Service Letter SL 57 R1	DO - No. EASA.21J.020
--	------------------------------------	----------------------------------

Planning Information

Re-Positioning of de-ice cables to improve long time wear. During the next inspection/repair or overhaul the de-ice cables should be re-oriented to reduce the wear .

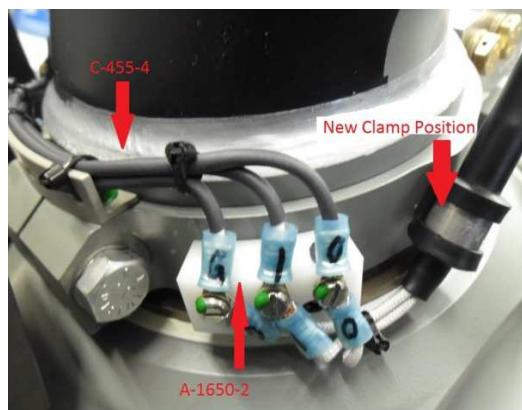
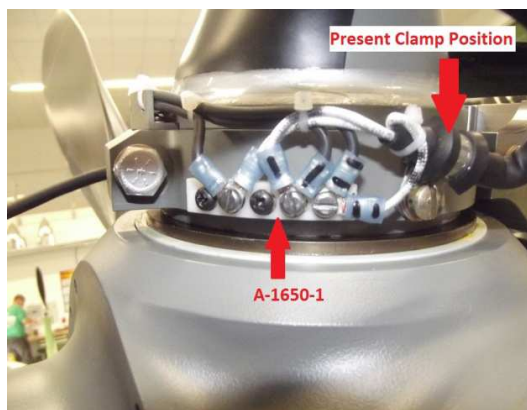
During operation some damages on the de-ice cables were reported.

- Cable clamp repositioning and replacement of Clamp A-1650-1 by A-1650-2
- Stop nut are reusable up to 3 times
- No special tools required

- 5x A-1650-2 (replacement for A-1650-1)
- 5x C-455-4 (wire)
- 5x 4E2071-3 or RAC165013-0604 (Deice cable)
